**INTER-OFFICE CORRESPONDENCE**

**SUBJECT:** **Administrative Site Plan Review –§3.1.7 and §7.5.2  
Boston College Middle Campus, 140 Commonwealth Avenue**

## ZONING REVIEW MEMORANDUM

MEMORANDUM

### Walkway Detail

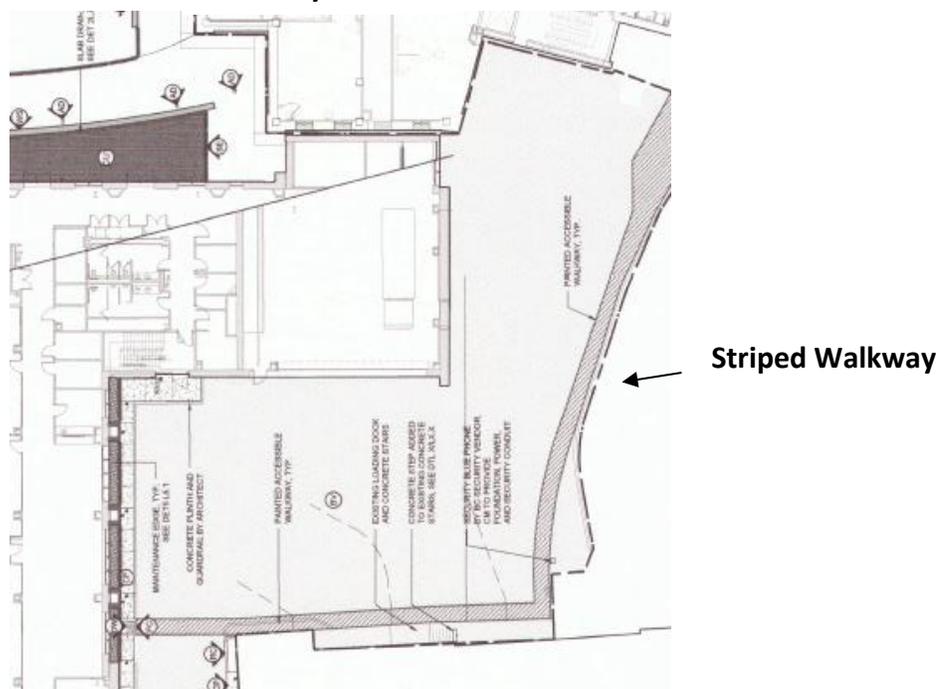
The Petitioner is also proposing full-depth reconstruction of a large paving area to the east of the ISB, which is where all loading will take place. The Petitioner is proposing to stripe a pedestrian walkway in this area running along the northern edge of the Service Building and continuing onto Higgins Path, which is a pedestrian walkway connecting to Higgins Stairs and other Middle Campus structures. The Planning Department suggests the Petitioner convert this walkway into a raised, concrete sidewalk to separate pedestrians from all vehicular traffic.

- Comply with all conditions identified in the Engineering Memorandum, dated March 25, 2019;
- Consider constructing the striped pedestrian pathway east of the ISB in the form of a raised concrete sidewalk; and

*Schematic Design*

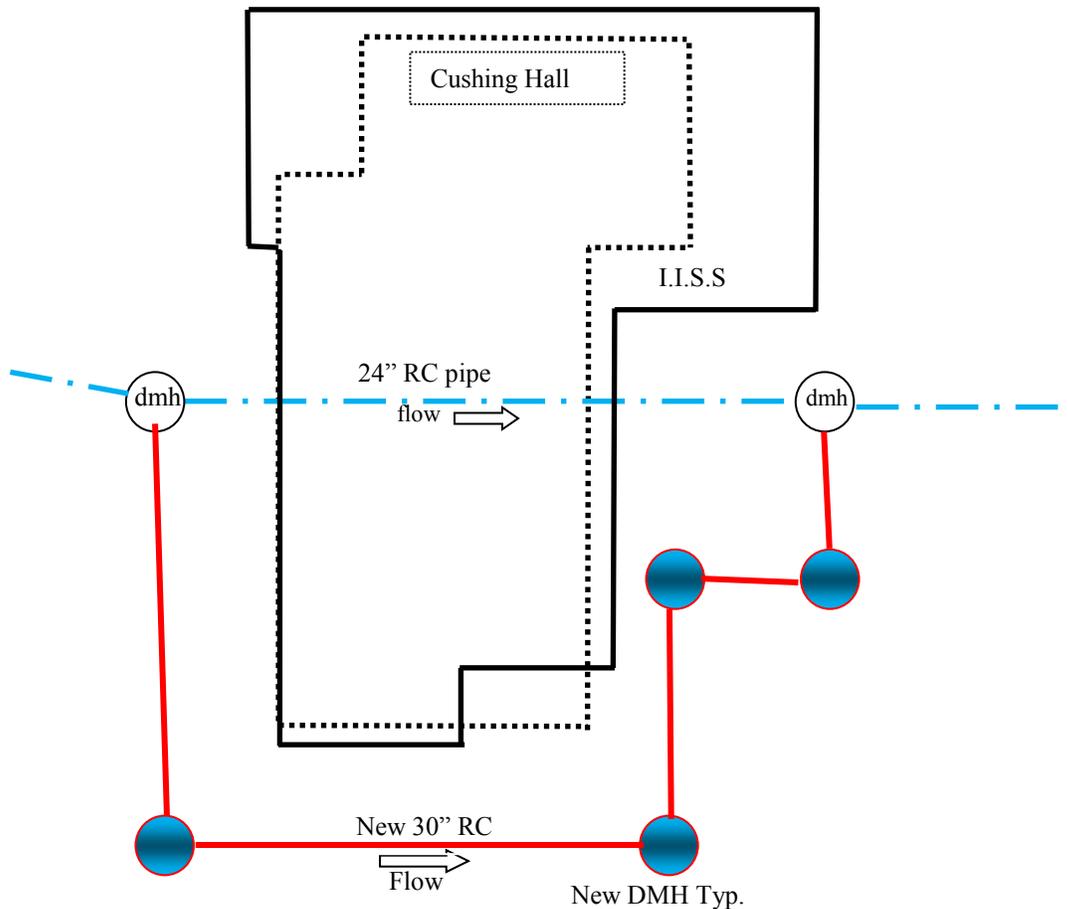
Boston College wishes to erect a new *Institute Integrated Science & Society* (IISS) building located in the middle campus to replace the existing Cushing Hall. A complete demolition of Cushing Hall is required to building the new facility; associated with the demolition and new construction, a portion of an existing City drain pipe and easement that currently runs under Cushing Hall which dates to 1916 must be relocated. The engineer of record has designed a re-routed system & easement that connects at an upstream manhole and diverts the alignment outside of the footprint of the new building; see schematic sketch for clarification.

1. Details of the 15” flow restriction is needed and clarification of its exact placement within the new pipe.
2. An on-site soil evaluation needs to be performed to obtain the seasonal high groundwater elevation, percolation rate in accordance to Title V. This information must be submitted with the building permit application. The locations of these tests need to be shown on the site plan.

The new 30” reinforced concrete pipe and manholes will be located into a new easement that will be granted to the City, this is being processed by a separate filing with the Public Facilities Committee.
